MEMORANDUM

Subject: RZN18-0006/ORD 1868-Request to rezone 3.0 acres of vacant land from RM-48 Medium Density Multi-Unit Residential to PR Planned Residential at 1435 Toms Creek Road (Tax Parcel No. 195-A 18) for the development of a multi-family student housing development by Kirk Johnson of Graystone Properties, LLC (applicant/contract purchaser) and Thomas D (III) Frith, J. Patrick Frith and Eric Frith (property owners).

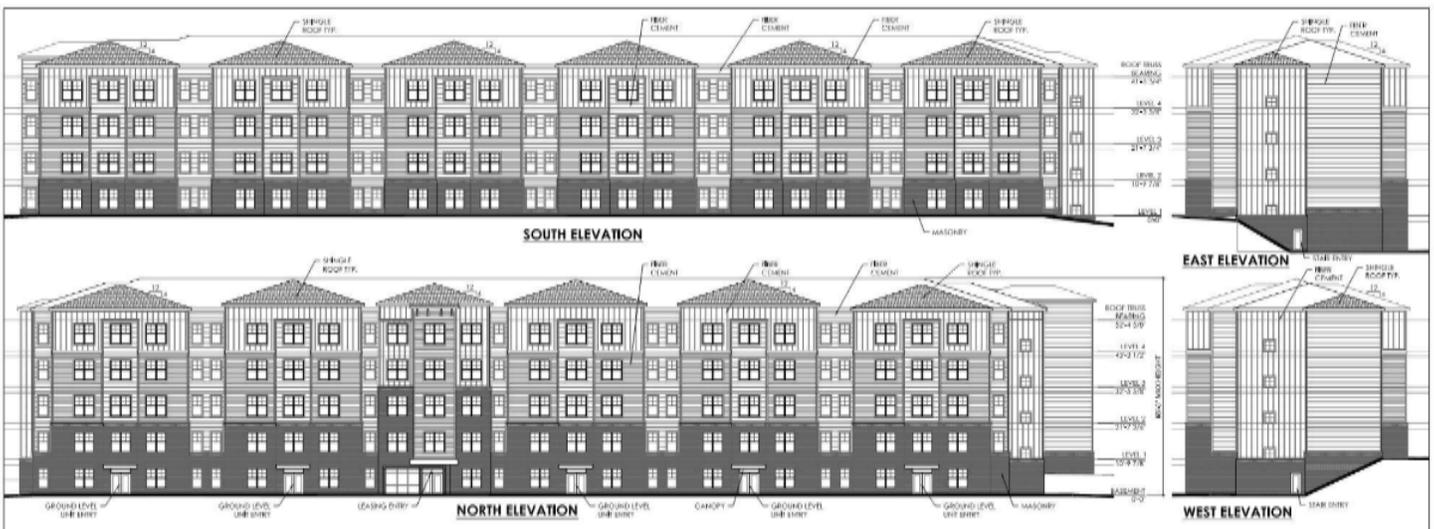
The designer did an effective job breaking down the long façade into smaller pieces by dividing the building into six portions, although the design is basic and a bit monotonous. The façade can be broken up further by adding vertical reliefs and reveals on the wall that accentuate its height and detract from its width. Taller windows may also help make the building seem lighter.

The material changes add visual interest and help divide the tall building into three distinct sections, making it feel more human scaled. However, the Town should insist that high quality materials such as stone and fiber cement siding are used. Cheaper alternatives such as vinyl siding do not age well over time and are not appropriate for multi-family developments such as this.

The design for the building can be improved by making the lobby/common area more prominent. At a functional level, the main entrance needs to be easily identifiable to detract guests and newcomers from approaching the ground level unit entries. Beyond that, it's also important to consider that this common area is the first space potential renters will see, and it can also serve as a social space for the apartment where students can relax, study, hang out, and collaborate. Thus, it's important that the space is highly visible and visually appealing.

Unfortunately, in this case the entrance is not centered on the building and has a commercial-style window on only one side, making it feel strangely lopsided. The differentiating fiber material directly above the doorway and the larger canopy helps accentuate it to a degree, but more should be done to enhance this key area of the building. At a minimum, matching commercial-style windows should be on both sides of the door and landscaping should be used to help make this area a focal point. It may also be helpful to change the style of the canopy to further differentiate it from the overhangs above the ground level entry units.

Another consideration is the window sizes and placements. Currently, the design has three main windows and two smaller windows for the four-bedroom units. Assuming that the living room will have a main window, only two of the bedrooms will have a main window and the other two will have smaller windows. Because student bedrooms are typically smaller than the average bedroom, consider adjusting the floor plan and window placements to allow all bedrooms to have windows the size of the main windows. This ensures that every user of the unit will have a bedroom that will appear more spacious and will allow for more natural light. For the southern façade, it may be appropriate to add overhangs of appropriate depth to cast off direct sunlight over the summer.

TRANSPORTATION SYSTEM & CONNECTIVITY

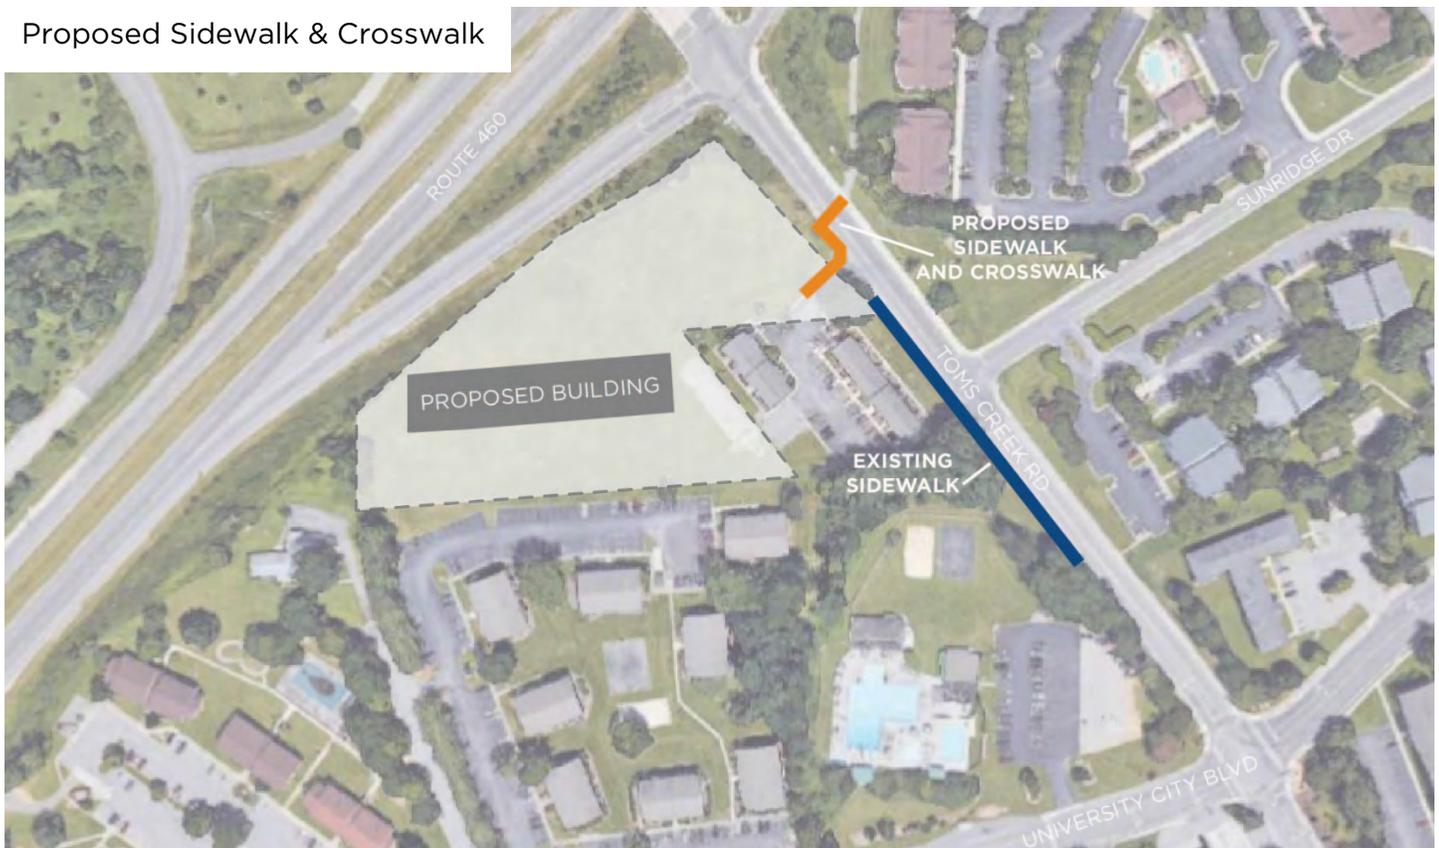
Although some basic pedestrian accommodations have been made, the layout for The View is not particularly pedestrian friendly. As currently designed, a pedestrian must walk over 400 feet from the building through a parking lot to Toms Creek Road before beginning their journey. It will be important to ensure that there is an ADA accessible pathway from the Toms Creek sidewalk to the building. The plan does not currently show the required connection between the internal sidewalk network and the existing public sidewalk on Toms Creek Road, a basic issue which must be addressed along with the lack of a sidewalk ramp near the entrance to this site. Typically, a development such as this would be required to construct a sidewalk along the entire length of the property on Toms Creek Road. In this particular case, that sidewalk would not lead to any kind of pedestrian space on the existing overpass, so it may not be useful. However, the Town may want to consider requiring a short extension of the sidewalk in that direction in order to provide a better crossing to Givens Trail, a suggestion which discussed further in the following paragraph.

There are minimal provisions made for cyclists other than a few bike racks. The main two racks in the front of the building are placed directly in front of the ground level unit entry doors, suggesting that little thought has been put into their inclusion. The applicant doesn't provide any specific information about the racks, but an inverted u-type rack should be utilized as it provides support for the frame of the bike and offers better security. In order to truly encourage cycling, these racks should be covered,

Transit Access

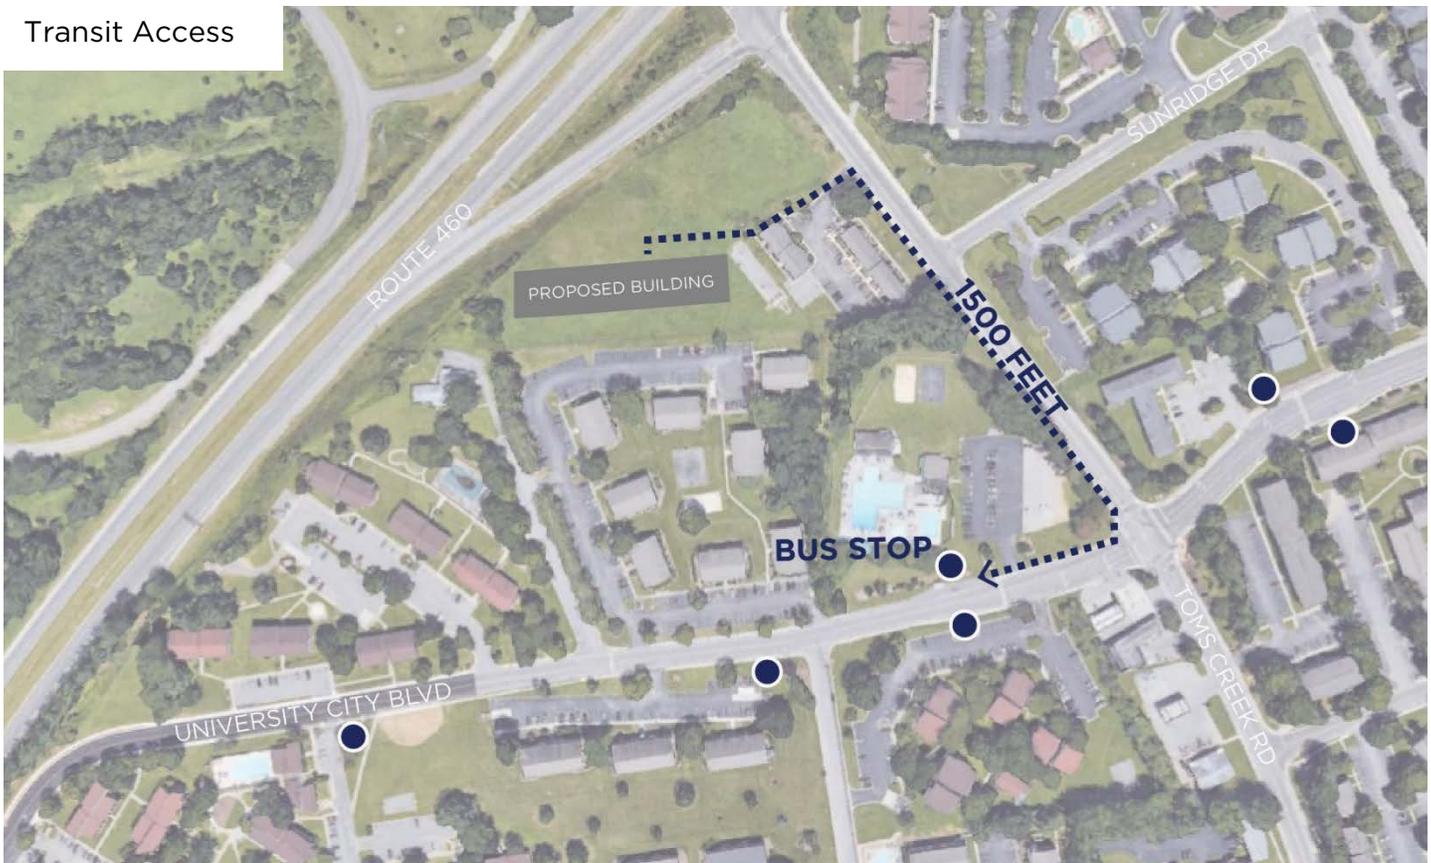
Transit use by residents will mitigate traffic and reduce the need for parking at the apartment complex. The applicant notes the distance to the closest bus stop is approximately 600 feet. However, due to the layout of the site and the lack of connectivity to neighboring properties, the actual travel distance for pedestrians to get to the bus stop will be significantly longer and will be somewhat difficult due to the grading of the site. Assuming residents don’t trespass on adjacent residential properties for a more direct route, their walking path from the building to the closet transit stop will be closer to 1,500 feet, or a 5-minute walk. This walking distance is reasonable, but is not as accessible as other properties directly on Patrick Henry Drive and farther south on Toms Creek Road.
